COP Test Procedure for PEV

NEW PROPOSAL

Current

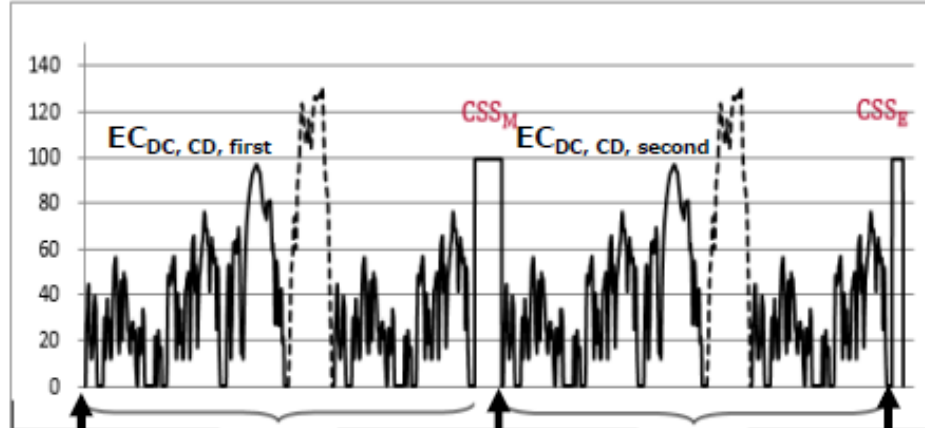
conduct one applicable cycle with fully charged battery,
then compare with EC_{DC, CD, first} between Homolo. and COP

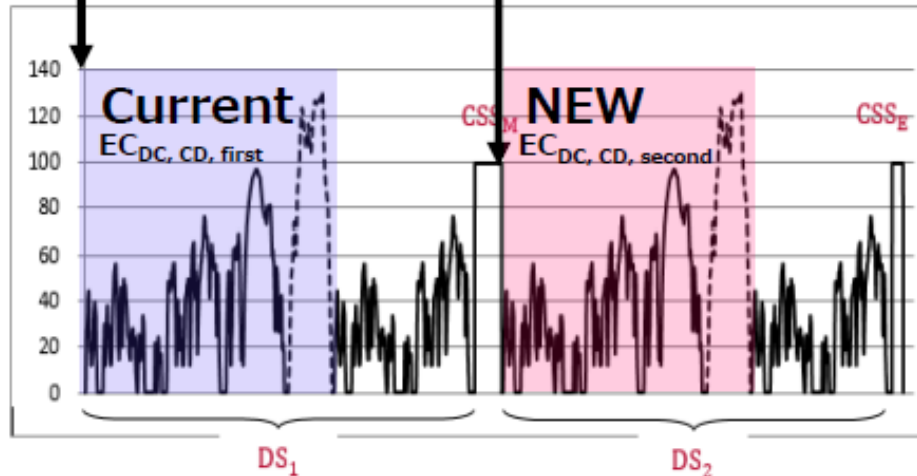
As an option,
allow to conduct one applicable cycle
under the same condition* with DS₂,
then compare with EC_{DC, CD, second}
between Homolo. and COP

*) REESS : SOC_DS₂ ±[5] %
or less than SOC_DS₂

Vehicle Condition :

- (1) immediately start after R/L setting
- or (2) 10 minutes @ CSS speed
- or (3) combine (1) and (2)
- or (4) accept unique warm up procedure
with technical authorities approval

【Justifications】

- ✓ same concept as currently agreed
- ✓ avoid to ship the vehicles with high SOC battery
- ✓ to comply with IATA requirement
(SOC should be less than 30%)
